FIRST DRAFT MINUTES

December 18, 2024, Standards Committee Meeting

RE: Minutes from the December 18, 2024, Standards Committee Meeting

INDIANA DEPARTMENT OF TRANSPORTATION	
FABRICATION TOLERANCES, INDEX, AND GENERAL NOTES	
SEPTEMBER 2022	
STANDARD DRAWING NO.	E 707-BPBF-01
	 06/15/2022 DESIGN STANDARDS ENGINEER DATE
	 06/27/2022 CHIEF ENGINEER DATE

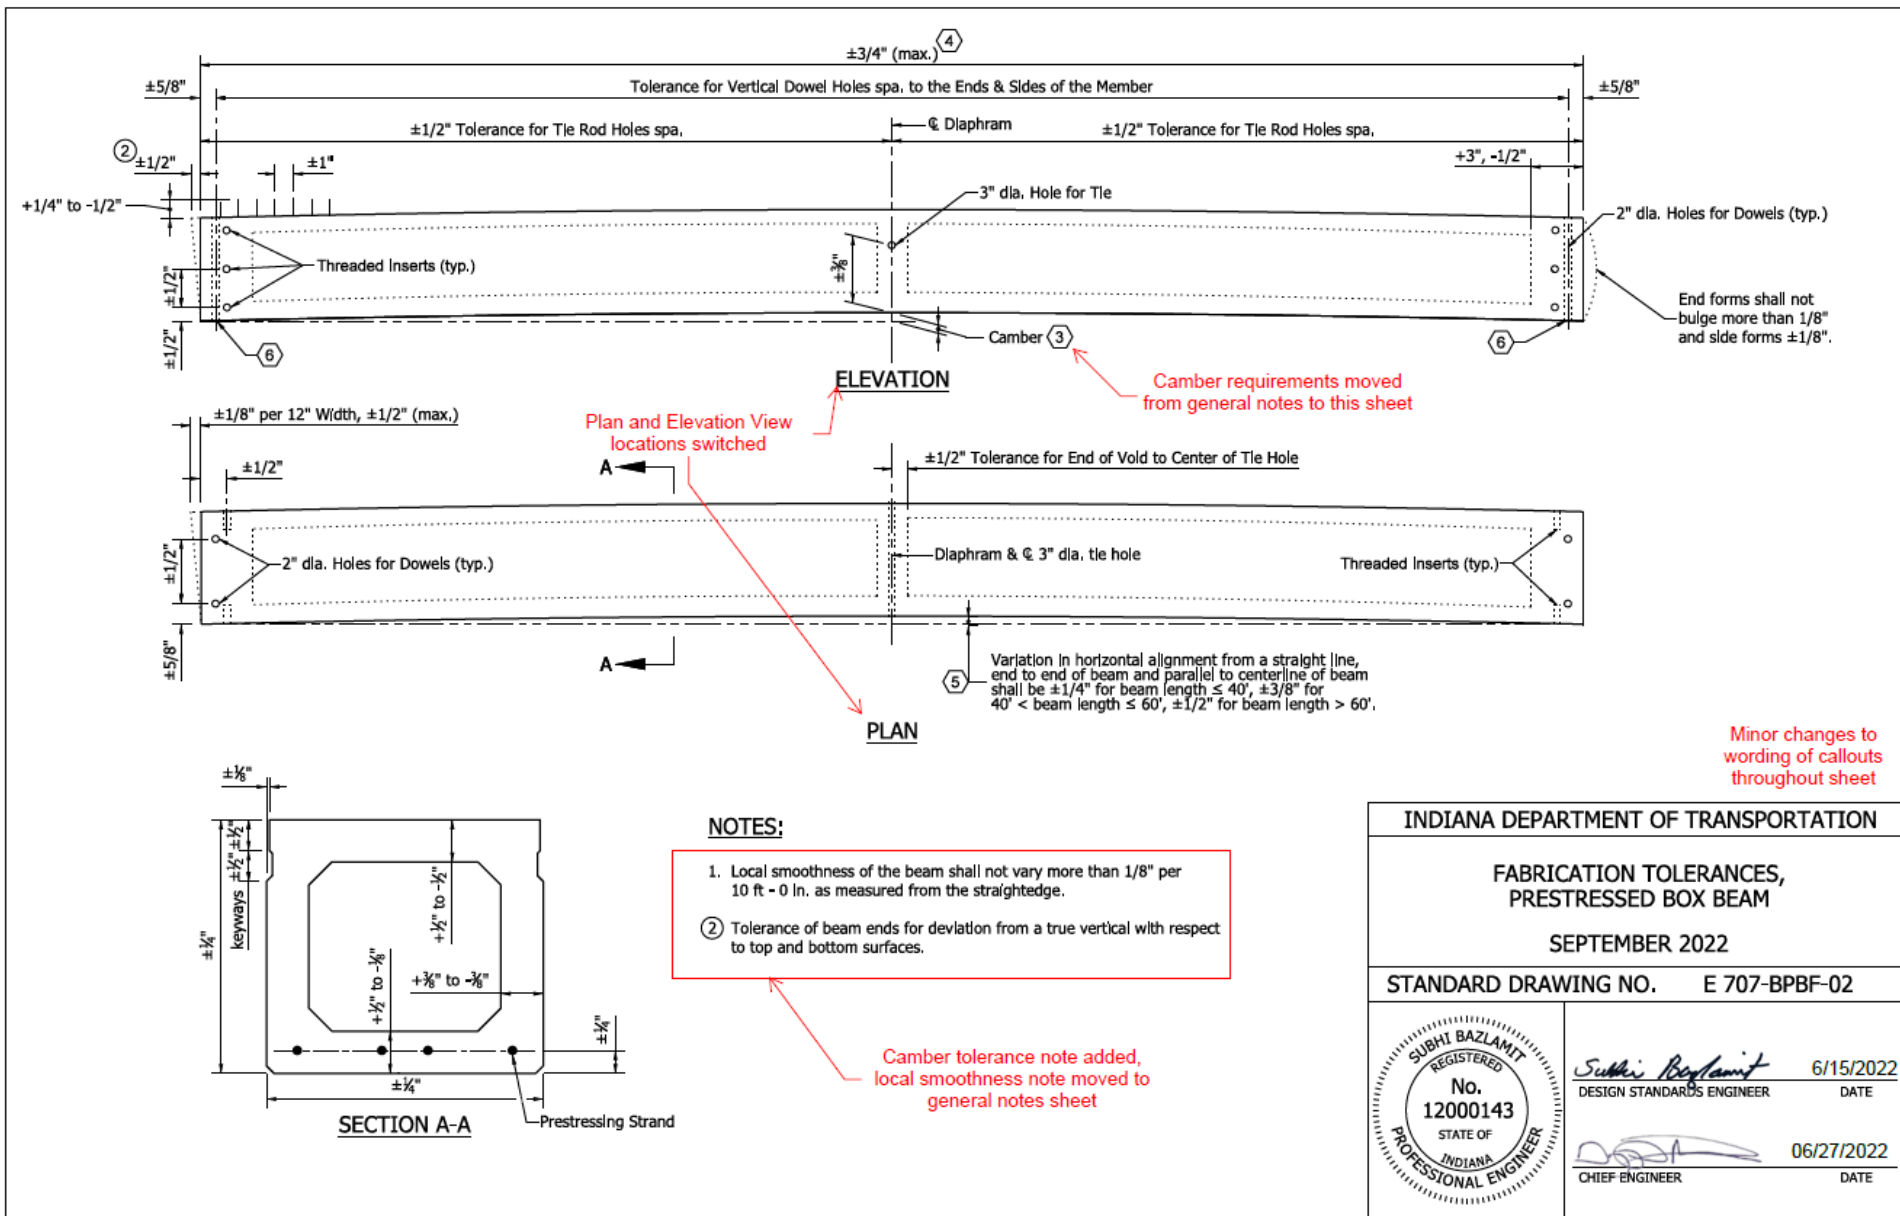
Symbols removed from general notes sheet.

Beam-specific tolerance notes moved to the applicable sheets

Local smoothness requirement moved from individual sheets to this sheet.

E 707-BPBF-04 FABRICATION TOLERANCES PRESTRESSED NEXT BEAM (proposed draft)

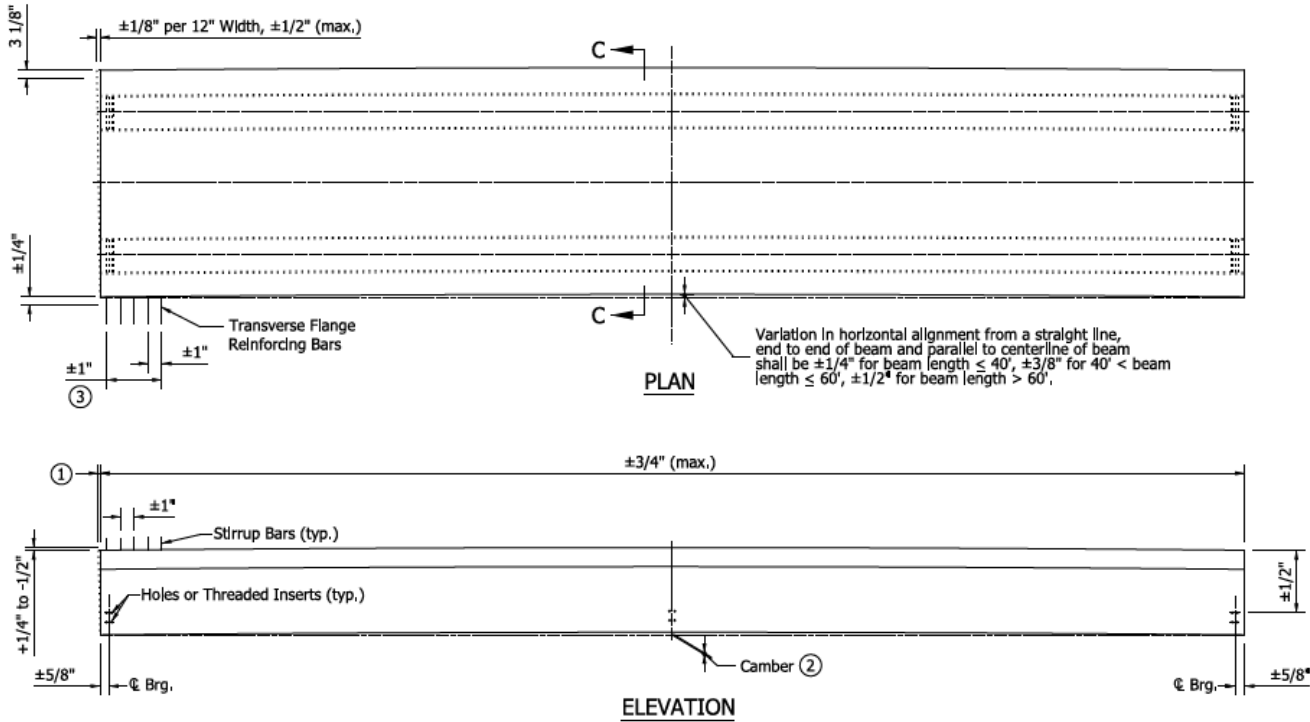
- ① Maximum variation from specified elevation end squareness or skew shall be ±1/8 in. per 12 in. of beam height, 1/2 in. max.
- ② Camber tolerance from camber shown on plans shall be ±1/8 in. per 10 ft length with ±1/2 in. maximum.
- ③ Spacing tolerance for transverse flange reinforcing bars that project beyond the edge of the top flange shall be measured relative to plan location of each bar and shall not be solely based on as-built location of the adjacent bars.
